Notice of Intent

HILCORP ENERGY COMPANY
FEDERAL 31 43
P&A NOI

Notice of Intent – Plug and Abandonment

Operator: Hilcorp Energy Company
Lease: NMNM 0003523
Well(s): Federal 31 43, US Well # 30-045-24965
Location: NESE Sec 31 T27N R11W (San Juan County, NM)
Sundry Notice ID #: 2875449

FEDERAL 31 43 - PROPOSED WELLBORE SCHEMATIC

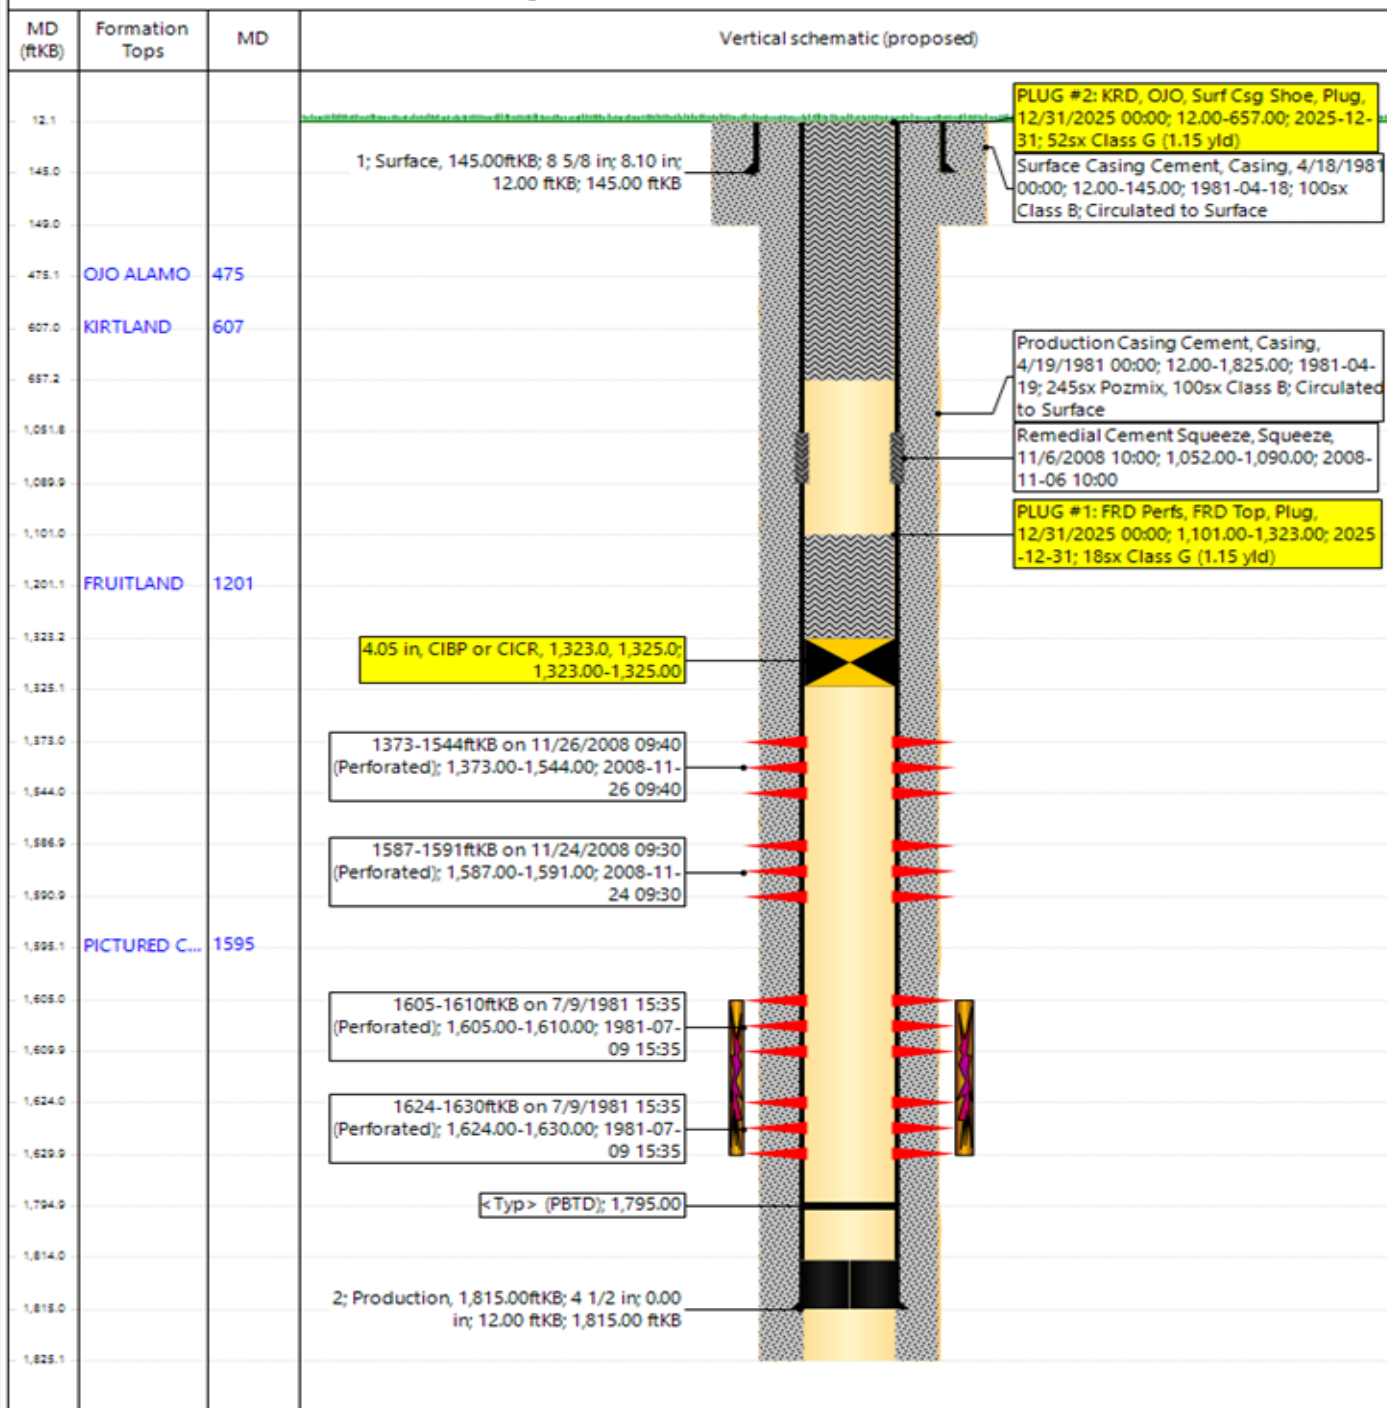
Available raster logs support operator selected formation tops. No changes to the procedure.

1. Plugging operations authorized are subject to the attached "General Requirements for Permanent Abandonment of Wells on Federal and Indian Lease."
2. The following modifications to your plugging program are to be made:
 - a. No changes to the procedure.
3. **Notification:** Farmington Office is to be notified at least 24 hours before the plugging operations commence at (505) 564 7750.

You are also required to place cement excesses per 4.2 and 4.4 of the attached General Requirements.
